# **Validation Report**

# **Validation Report (VAR)**

ER Program Name and Country:	East Kalimantan - Jurisdictional Emission Reductions (EK-JER) Program, INDONESIA
Crediting Period	01-07-2019 to 31-12-2024
Name of the VVB:	AENOR INTERNACIONAL S.A.U.
Contact information of the VVB:	Génova 6. 28004 Madrid - Spain. Telephone +34 914326000 jfuentes@aenor.com www.aenor.com
Date of the Validation Report:	06-07-2023
Version:	1.1
Report Approved by	José Luis Fuentes

Figure 5.1 Projected emission from peat decomposition to 2025 taking into account the inherited emission

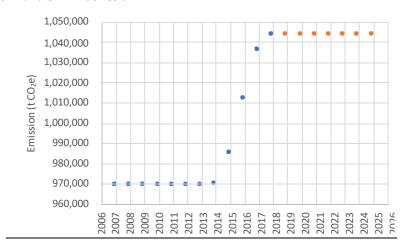
1- It is stated that "As Indonesia does not meet the qualifications for an upward adjustment as outlined in the Methodological Framework, and the Methodological Framework does not otherwise consider the uniqueness of peat forests, the CFPs agreed to provide a one-time waiver to Indicator 13.1 of the Methodological Framework \*...+. The implications of this decision for the final Reference Emission Level is that the estimated emissions from peat degradation will increase from 975.631 tCO2e/yr (the average over the reference period) to 1,036,236 tCO2e in 2017 and 1,043,684 tCO2e in 2018, staying constant for years after 2018". It is not clear the quantification of the adjustment (column Adjustment, if applicable (tCO2-e/yr) is now empty). Please provide it in a table with the change per year regarding the

- 2- Although it seems that finally an upward adjustment was done (as a CFP exemption), apparently the adjustment was from 27,469,856.40 tCO2e/yr (MR Annex 4: section 8.4) to 27,448,712.07 tCO2e/yr (MR Annex 4: section 8.5), that means a downward. Please, clarify the final RL used, since in section MR 4.1 the RL reported and used as final for the FCPF ER calculation is 'pre-adjustment' (the one reported in MR Annex 4: 8.4).

- 3- Section MR Annex 4: 8.5 lacks a clear 'executive summary of assumptions, methods and results of any underlying studies that have been used to determine the adjustment' (according to MR template), particularly a comprehensive explanation of the quantification methods and final results ('complete calculation for the quantification of the proposed upward or downward adjustment to the average annual historical emissions over the Reference Period. Provide a step-by-step estimation of the expected emissions that would result from documented changes in ER Program circumstances. Attach any documents or spreadsheets used in the calculation'). In case the current values in MR Annex 4: 8.4 are the adjusted ones, please provide the same information but regarding the ones provided currently in MR Annex 5: 8.5 (if this ones are the pre-adjusted).

- 1. Based on Resolution CFM/19/2019/1
  - (https://www.forestcarbonpartnership.org/system/files/documents/Resolution%20CFM\_19\_1\_End orsement%20of%20Indoneisa%20ER%20Program%20FINAL.pdf), in which 'the CFPs and Program Participant agreed to remove the calculation for emissions associated with projected future deforestation in peat forest and apply the estimate of the most recent data not later than 2018
- 2. Corrections were made in Annex 4, 8.4. The figures used are 27,469,856.40 tCO2e/yr
- Calculations are in the excel file
   https://mrv.kaltimprov.go.id/storage/guest/ERMR1/CarbonAccounting/fcpf ekjerp ermr1 MC 26J uli2022c.xlsx

Table in Annex 4: 8.4 has been revised. – See Page 158 in the Document

It has been clarified that an upward adjustment itself has not been applied, but the CFPs agreed to provide a one-time waiver to Indicator 13.1 of the MF to use emission level of peat decomposition year 2018 as baseline historical emission and keep it constant for years after 2018. Documented evidence was provided. Thus, the pending requests 1) and 3) are not longer required.
